# Conceptual Review Agenda

Schedule for 06/29/15 to 06/29/15

**Re:** 321 Old Firehouse Alley - Restaurant

**Description of project:** This is a request to locate a restaurant at 321 Old Firehouse Alley (Parcel #9712306012). As part of the restaurant, the applicant is proposing an 1,800 square foot courtyard. The restaurant could potentially house a microbrewery as well. The site is located in the Downtown (D) zone district. This proposal will be subject to Basic Development Review (BDR).

# Christian Brothers Automotive - Site Plan A

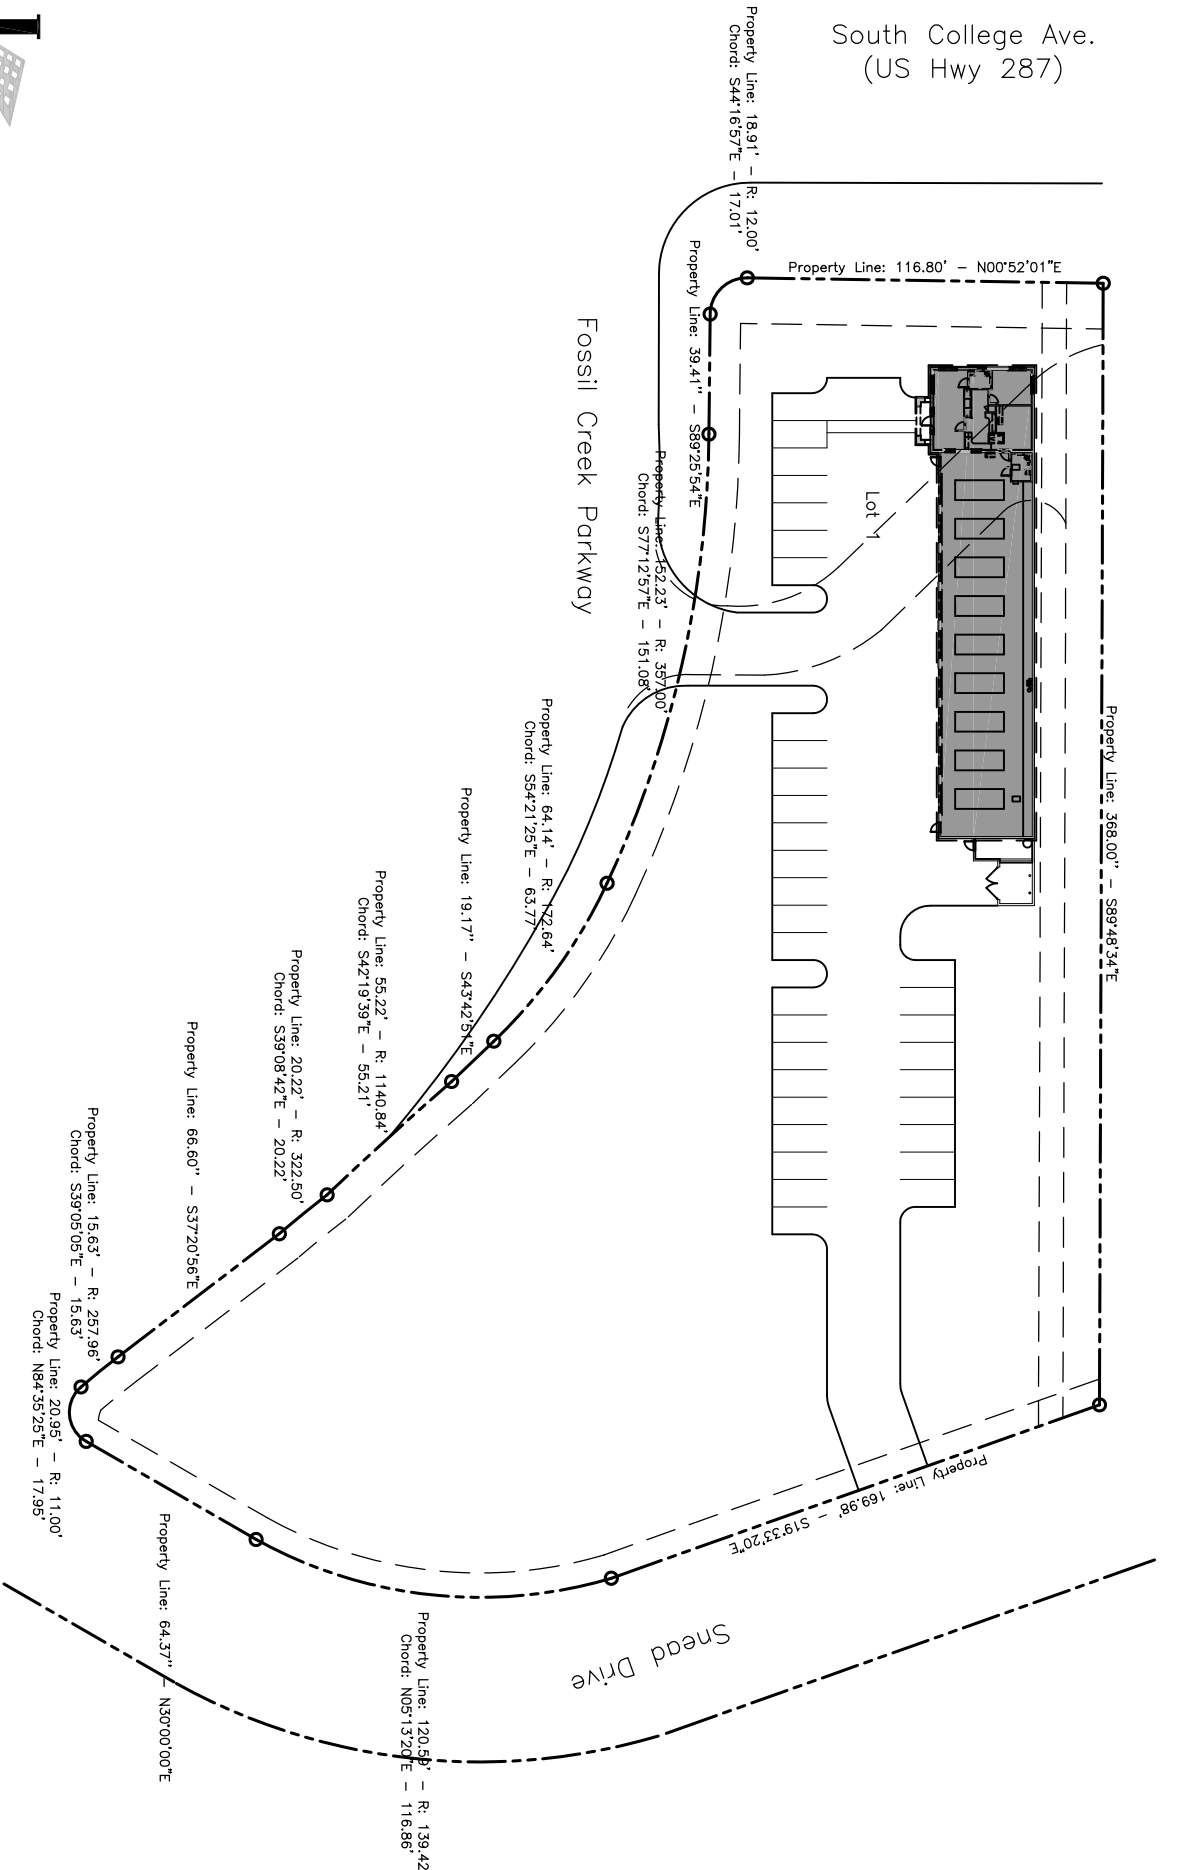
8. The current site plan shows 32 parking spaces. The maximum amount of parking allowed per section 3.2.2(K)(2) is 25 (5 spaces per 1,000 sq. feet of vehicle repair space). You will need to seek a modification to the parking standards to achieve the 32 parking spaces shown.

9. You will need to provide a handicapped parking space in accordance with section 3.2.2(K)(5) of the Land Use Code. If you reduce your parking stalls to 25, you will be required to provide 1 handicapped parking space. If you look to achieve the 32 parking spaces as shown on your site plan, you will need to provide 2 handicapped parking spaces.

1 Concept Site Plan  
 1" = 20'-0"

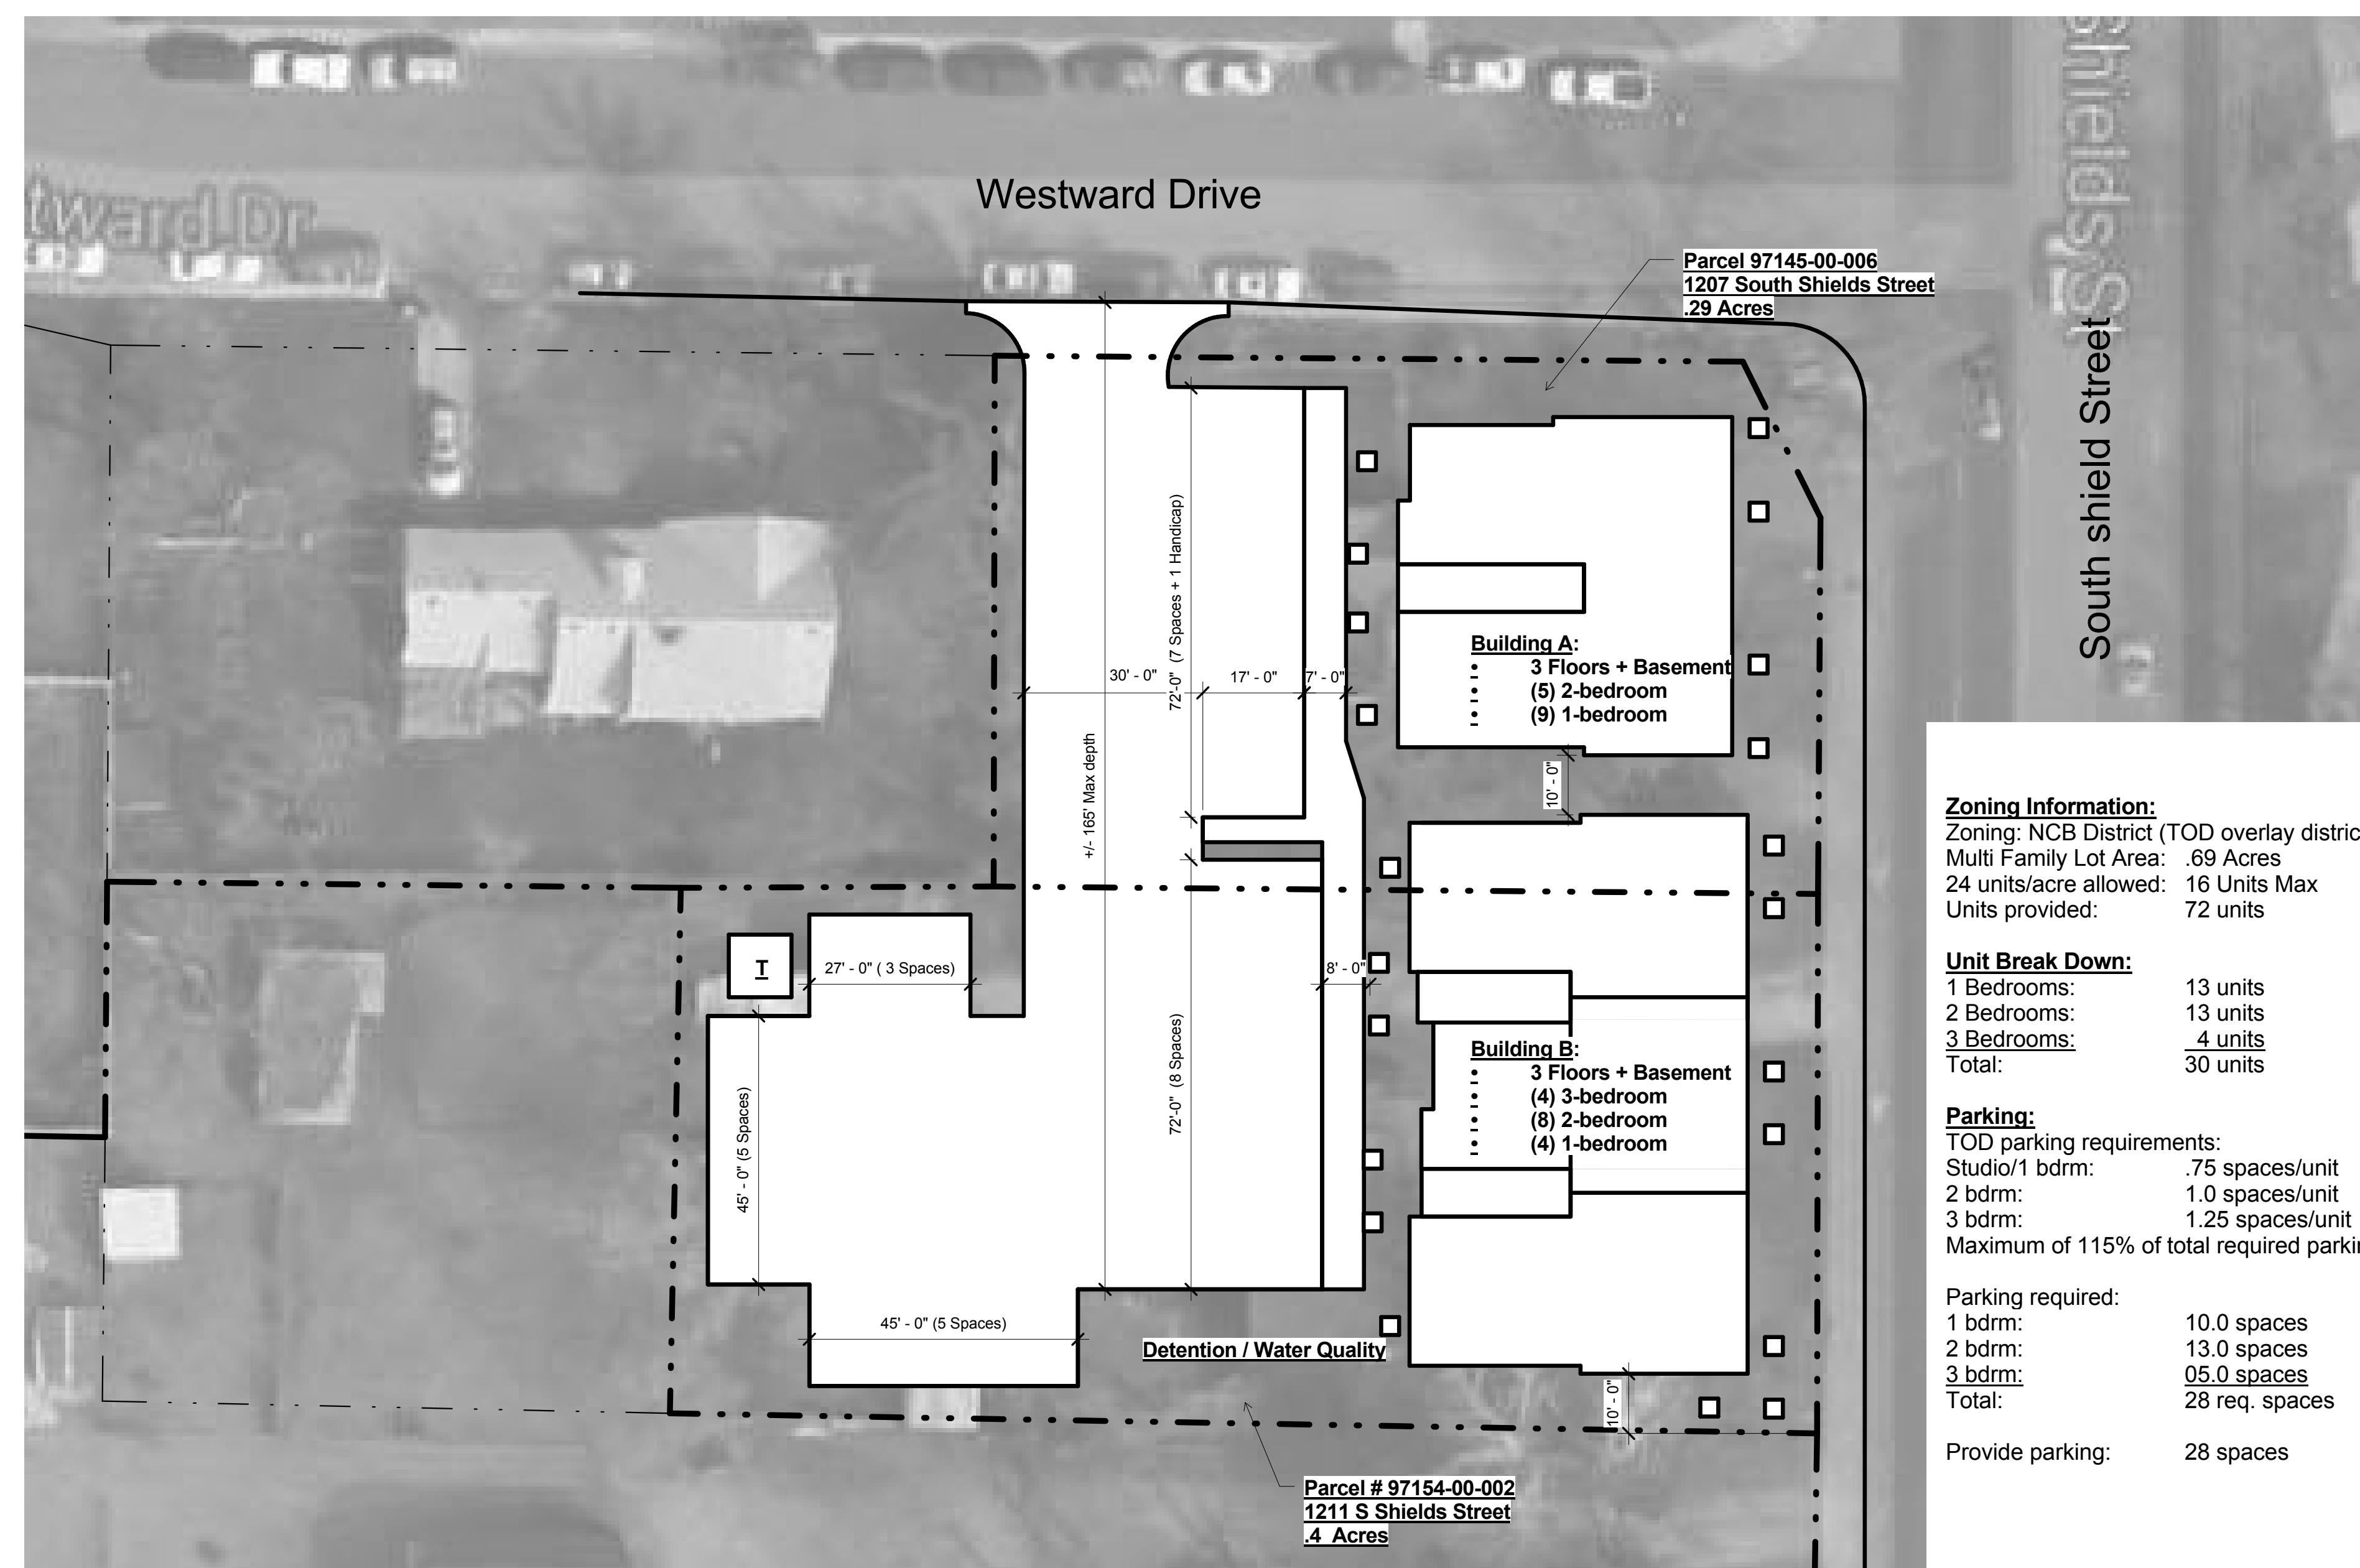
4. What are the front and street-side setbacks shown? Front and street side setbacks are 15' min. What are the square elements shown on the plan? Are these column bases?

5. How are the three story buildings articulated? The project must provide significant building façade articulation per the NCB and TOD building standards that respond to the surrounding context. This also includes a transitional setback requirement along the south for walls that are greater than 18 feet in height. This is shown in the diagram in LUC 4.7(E) Figure 17.

12. The parking lot island must be at least 8 feet wide in order to provide at least 7 feet of clear landscape width for a shade tree per LUC 3.2.1(E)(5)(c). The initial submittal must also demonstrate that the parking lot interior and perimeter standards are being met. Document how this is being met on the submittal plans.
